Case Officer: EC
Planning Committee 13th March 2023

Application No: CHE/22/00592/OUT

**PROPOSAL: RESIDENTIAL DEVELOPMENT OF TWO DWELLINGS -
RE-SUBMISSION OF CHE/21/00143/OUT**

**LOCATION: REAR OF 66 SOUTH STREET NORTH, NEW WHITTINGTON,
S43 2AB FOR RAWSON RESIDENTIAL RENOVATIONS LTD**

Indicative site plan

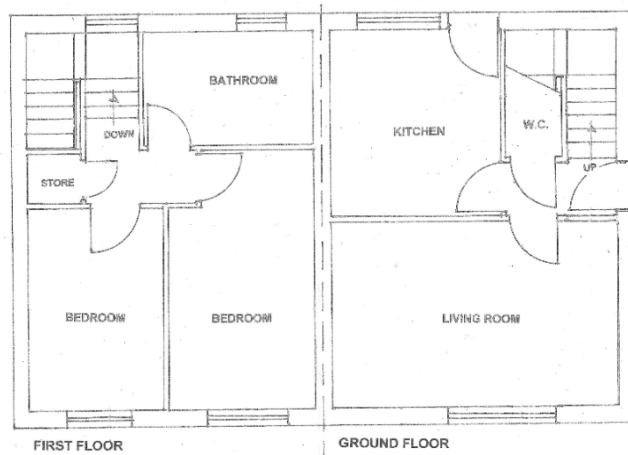
- 5.7.7 The submitted indicative plans show two dwellings with an angled boundary to the west with the new rear boundary of No 66 (and now No 68 South Street North). The adopted Successful Place SPD requires a minimum of 50sqm private amenity space for a two bedroom dwelling therefore the amenity space as shown although indicative would meet the requirements

- 5.7.8 The indicative layout provides further detail to assess the proposal and consider whether the scheme could provide appropriate separation between the existing and proposed dwellings. On the basis of the submitted indicative plan it is considered that a separation distance of approximately 20m could be achieved between the rear facing windows of No 66/68 South Street North and the proposed dwellings. A separation distance of 16m to 16.5m could be achieved between the indicative windows and the rear windows of existing dwelling No 52/54 South Street North.

- 5.7.9 The adopted Successful Place SPD sets out the minimum recommended separation distances between direct facing windows to be 21m (at 90-degree angle). The SPD sets out minimum recommended separation distance for different angles of site with a recommended separation distance of 18m for 70 degree to 90 degree angles of site.

- 5.7.10 It is accepted that the proposal is in outline with all matters reserved, however indicative layout plans have been provided to illustrate the scheme. In response to separation distances which are less than the minimum recommendation the design of the units has been altered to limit the number of first floor habitable room windows. The scheme will be required to include habitable rooms at ground floor to enable an outlook for future occupants and natural surveillance of the gardens. The scheme therefore does not appear to take into account habitable rooms at ground floor and proximity to existing nearby residential dwellings. The proposal would not meet the minimum recommended separation distances as set out within the SPD, therefore potentially resulting in adverse impacts of overlooking/loss of privacy to the residential neighbours to the west on South Street North.

- 5.7.11 The indicative layout shows two bedroom spaces, however it is worth noting that the width of the larger bedroom would not meet the minimum technical space standards at less than 2.75m wide.

- 5.7.12 It is also noted that due to the siting of the proposed dwellings, there would be a degree of overshadowing that will occur to the forecourt/parking area of Nos 48 and 50 South Street North immediately to the north of the application site.

- 5.7.13 The submitted scheme has been designed to attempt to demonstrate compliance with minimum standards, with minimum size parking spaces with vehicles parking up to the principal elevation of the dwelling with side access doors to avoid conflict with the parking spaces. This altogether demonstrates that the proposal would result in overdevelopment of the plot resulting in dwellings which do not meet the minimum recommended standards. The proposed development has the potential to result in dwellings with a compromised design to address the constraints of the site, which would not be in keeping with the character of the area resulting in a cramped scheme contrary to the prevailing character of the area and inadequate separation
